RE: AFC Supplement D
Cosumnes Power Plant (01-AFC-19)

COSUMNES POWER PLANT (01-AFC-19)

AFC SUPPLEMENT D (Pipeline Realignment of "Alignment 3A" and Revised Construction Laydown Area)

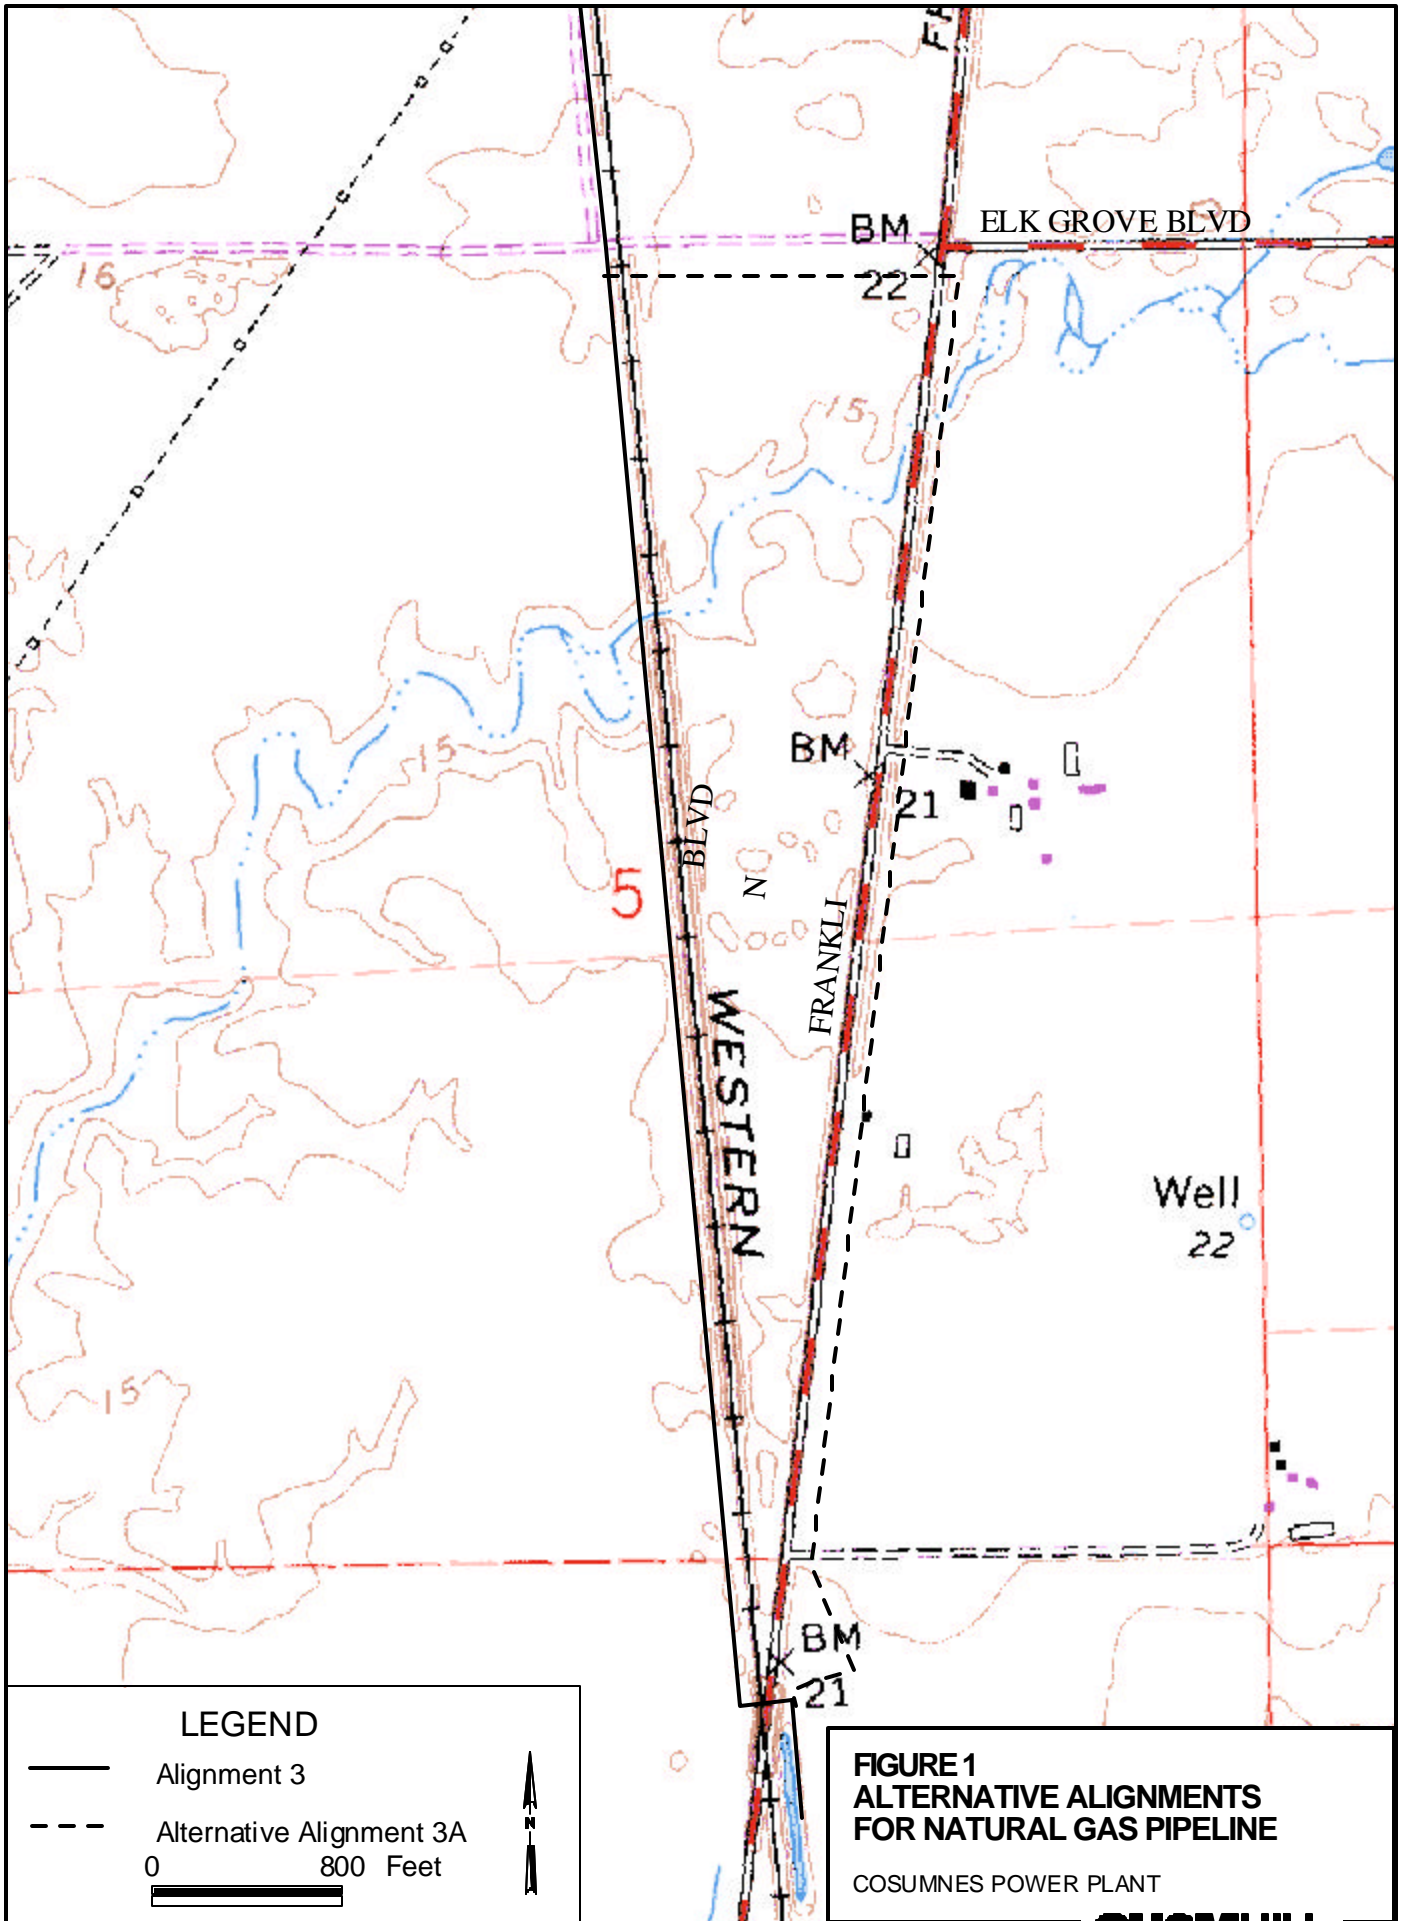
SMUD is also proposing a revised laydown area to use for site construction to reduce impacts to vernal pools and an ephemeral swale on the south side of Clay East Road. In the September 19, 2002 meeting, the USFWS and CEC staff also expressed a concern for minimizing potential impacts to vernal pools and ephemeral swales in and near the construction laydown area. In response, SMUD proposes to revise the location of the construction laydown area so that it still contains 20 acres, but is narrower and extends further south than previously proposed. This alternative laydown area would fill the "east"

Supplement D provides an environmental analysis of an optional construction laydown site arrangement to replace the two proposed in Figure 2.2-3 of the AFC. In response to CEC and USFWS comments, SMUD is willing to limit the laydown area to a parcel south of Clay East Road, and to extend it in an irregular elongated polygon to minimize impacts to vernal pools, ephemeral swales and the biota that may inhabit them. The alternative laydown area would be at one location rather than two as shown in the AFC, and would be constrained on the east by a vernal pool and to the west by an ephemeral swale and other wetlands. The alternative laydown area would extend south of Clay East Road approximately 1,000 feet on the same property originally proposed. The alternative laydown area is depicted in Figure 2.

**FIGURE 1
ALTERNATIVE ALIGNMENTS
FOR NATURAL GAS PIPELINE**

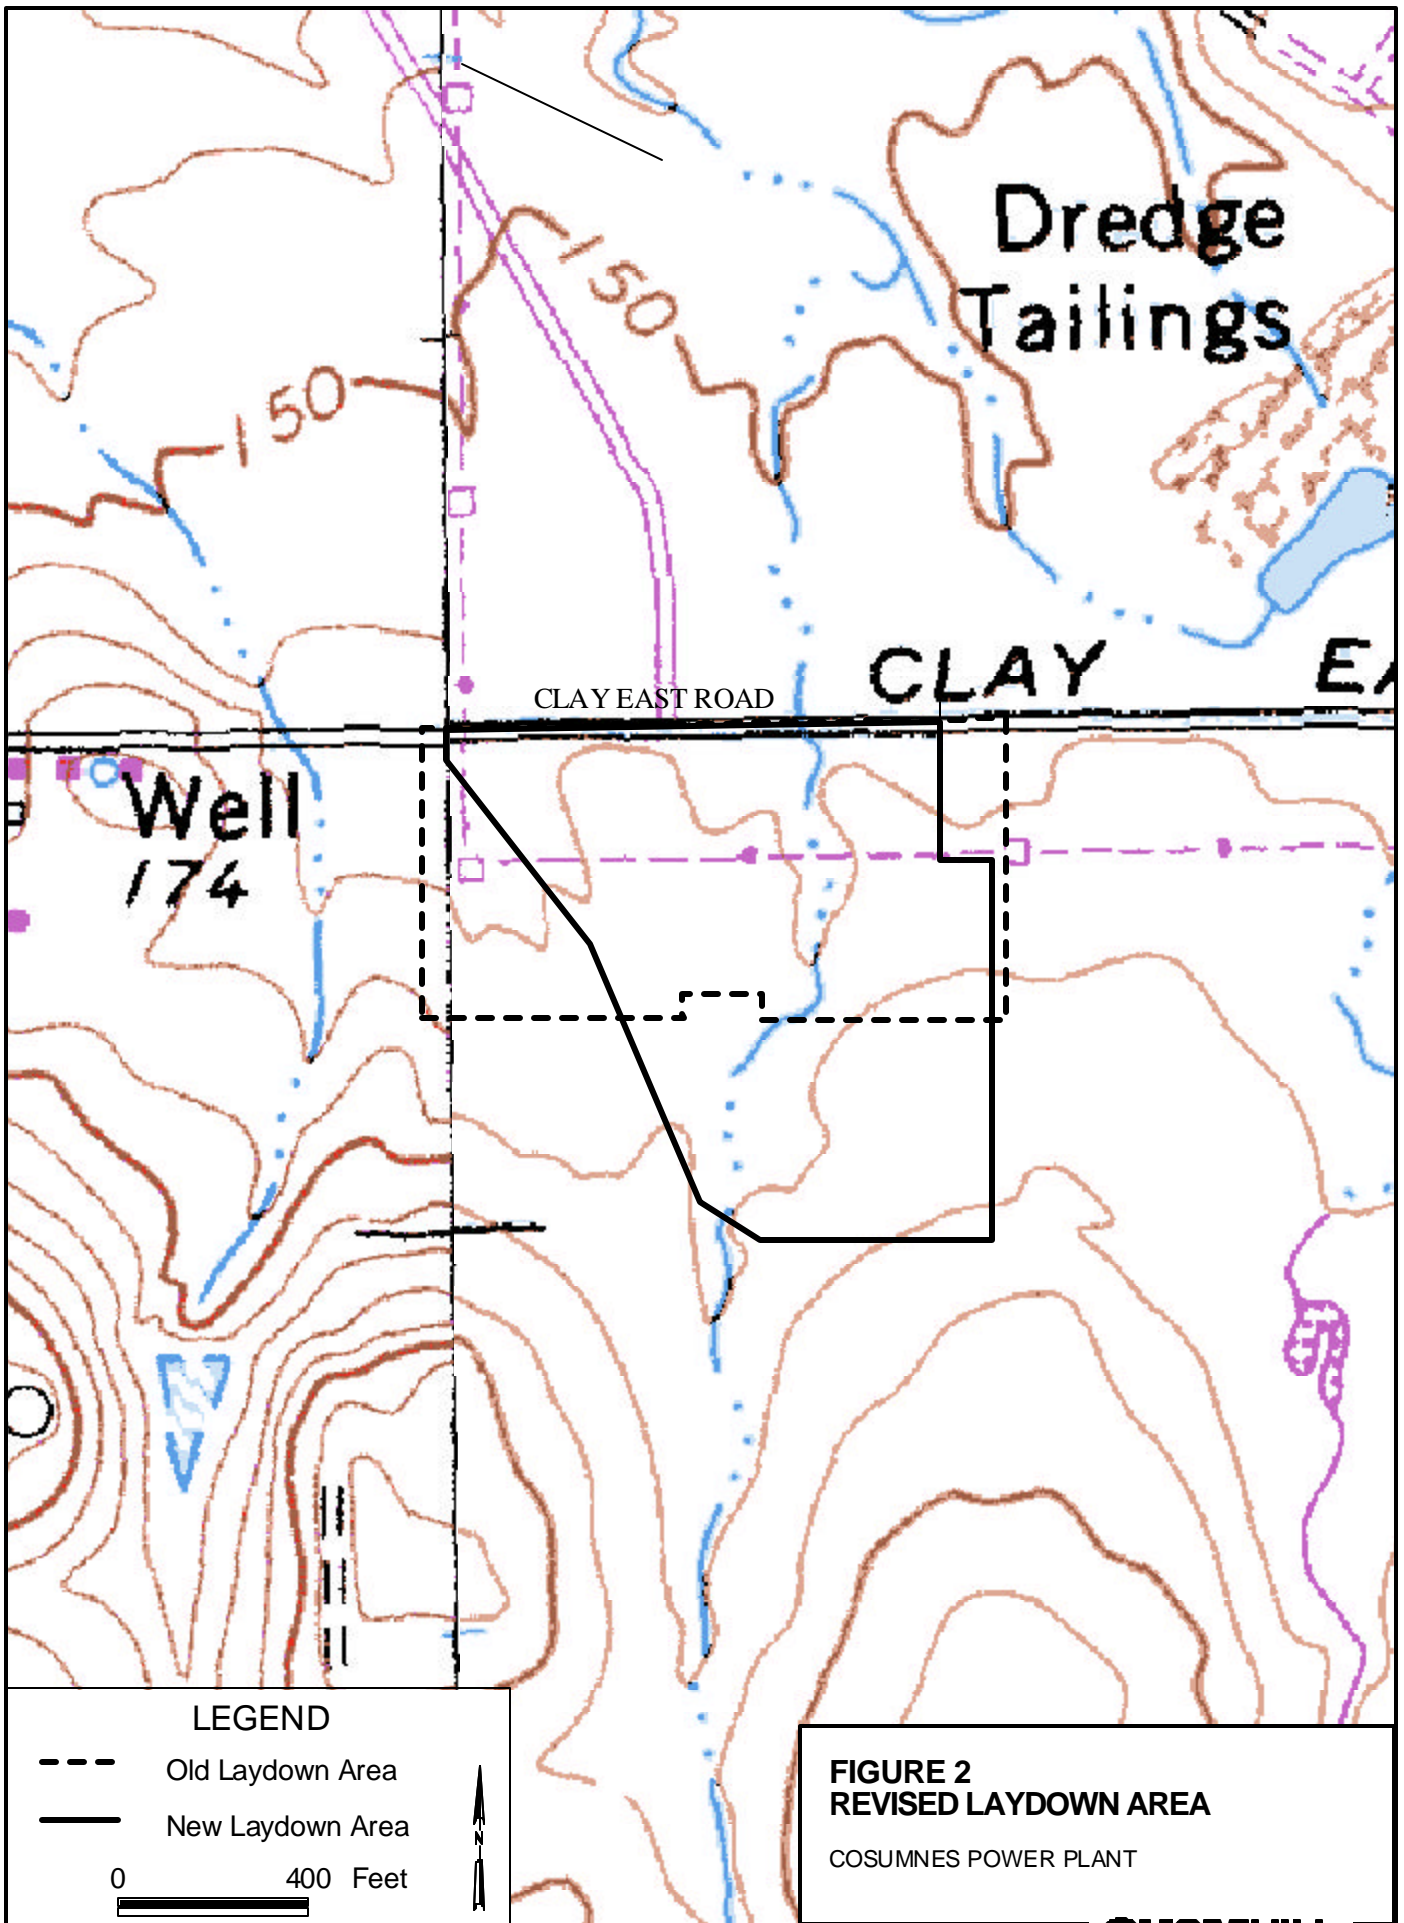
SMUD is now proposing as an option to realign a portion of the natural gas pipeline route to avoid a biologically sensitive area south of Elk Grove Boulevard, and west of the Union Pacific Railroad corridor. On September 19, 2002, the US Fish and Wildlife Service (USFWS) and CEC staff expressed the opinion that the then-proposed alignment along the eastern edge of the Stone Lakes-Laguna Wetland Preserve area could cause unmitigatable adverse impacts to listed and sensitive species. SMUD offered several alternative alignments and discussed the potential environmental impacts of each one. The USFWS and CEC staff expressed unanimous preference for an alignment that would go under or adjacent to Franklin Road, approximately 0.25 mile east of the current proposal ("Alignment 3A"). SMUD is willing to construct either route. However, since the Franklin Road route was not previously analyzed, this Supplement D provides an analysis of that alternative route.

The Franklin Road alignment (Alignment 3A), will substantially reduce the area of potential impact of the gas pipeline on vernal pools, vernal pool fairy shrimp, vernal pool tadpole shrimp and Valley Elderberry longhorn beetles (VELB); all of which are listed or sensitive species and habitats. Alignment 3A will require more time to construct because of the other infrastructure (paved road, pipelines, underground electric) located along Franklin Boulevard and a crossing of Laguna South Canal, which may be considered habitat for the giant garter snake (GGS). Alignment 3A will also require more active traffic management, and will place the gas pipeline closer to residences, but the USFWS and CEC staff felt that these impacts are mitigatable; whereas, in their opinion, impacts to vernal pools were not.

Supplement D provides an environmental analysis of an optional alignment of a segment of the natural gas supply pipeline proposed in the AFC (Section 6.0). In response to CEC and USFWS comments, SMUD is willing to relocate the segment of gas pipeline that would have run between Elk Grove Boulevard and Franklin Boulevard west of the Union Pacific Railroad. The alternative alignment will turn east on the south side of Elk Grove Boulevard, south on the east side of Franklin Boulevard and rejoin the original alignment at the point that it crosses under the Union Pacific Railroad (UPRR), near the Franklin Road crossing. The original and alternative alignments are shown on Figure 1. At the time the AFC was prepared the area east of Franklin Boulevard was rolling pasture and annual grassland, with scattered mature oaks that was used for grazing, agriculture or was fallow. At least one Swainson's hawk nest is present in this area. Subsequent to filing the AFC, the City of Elk Grove provided approved plans for developing all the area east of Franklin Boulevard as far south as Bilby Road for residential and commercial uses. As of October 21, 2002, the frontage of Franklin Boulevard from approximately 100 yards south of Laguna South Canal to the UPRR crossing has been cleared and graded with several dozen homes erected and additional construction daily. The area from Elk Grove Boulevard to approximately 100 yards south of Laguna South Canal is reserved for commercial development.
